<b>REGIONAL FAULT MAP (CALTRANS ARS ONLINE)</b>
PALO COMADO CANYON ROAD INTERCHANGE CITY OF AGOURA HILLS, CALIFORNIA

US101 Palo Comado Canyon Road OC  
Bridge No. 53-1678  
City of Agoura Hills, CA

**RESPONSE TO CALTRANS REVIEW COMMENTS**

**Subject:** Review of Preliminary Geotechnical Report for US 101 Palo Comado Canyon Road Interchange Improvement Project

**4a**

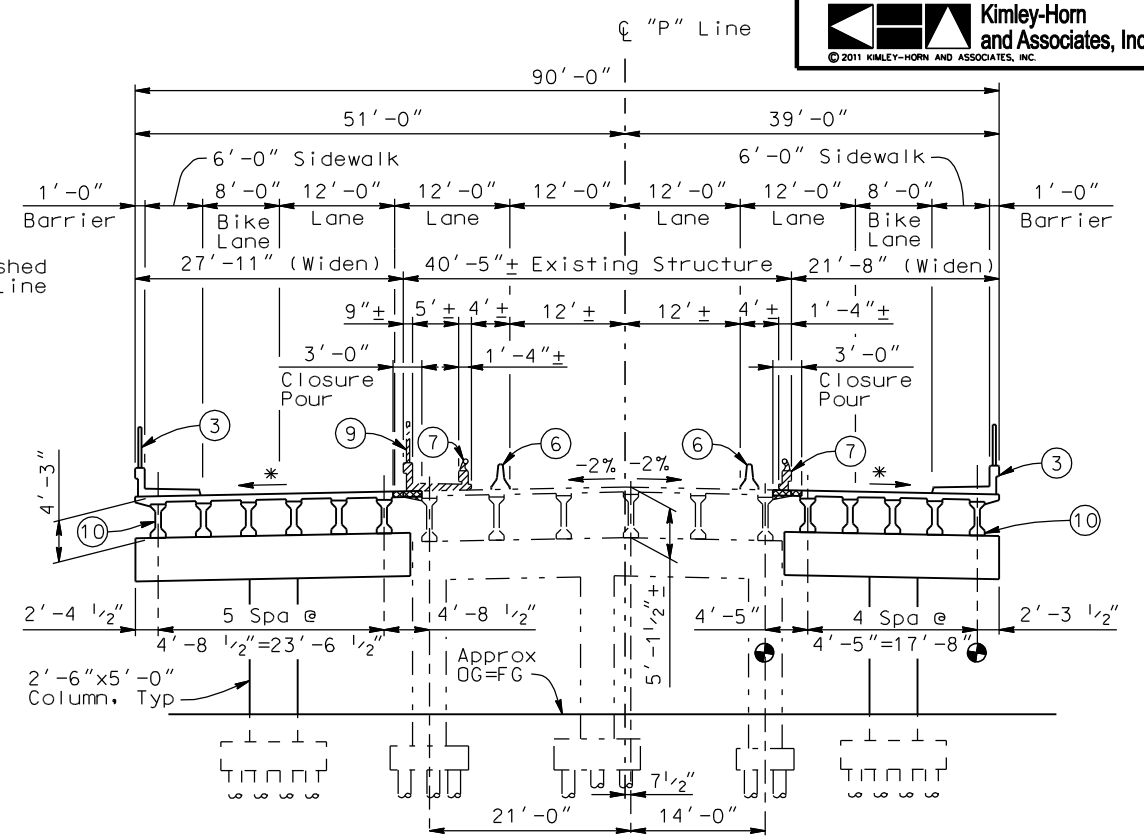
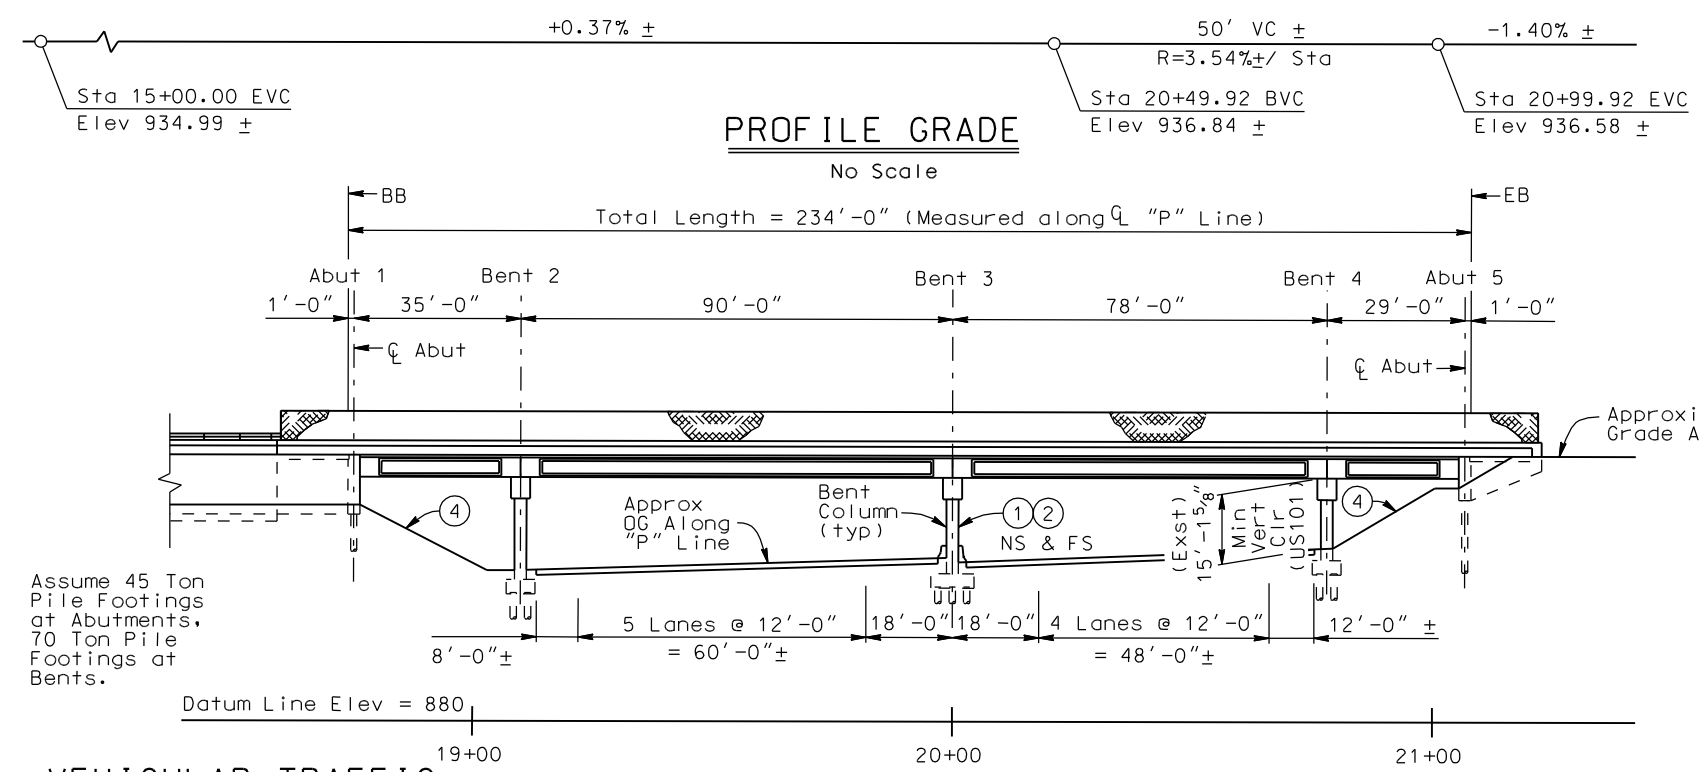
**Comment No. 2.** *Plate 4a: please provide calculation and/or reference backup for Displacement Response Spectral curve, and also describe the use of this curve in seismic analysis. If it is unnecessary information, please remove it.*

**Response to Comment No. 2.** Based on our communication with representatives of Kimley-Horn and Associates, Inc., we understand that the displacement response spectral curve is not required for analysis during this phase of the project. Therefore, it has been removed from our report.
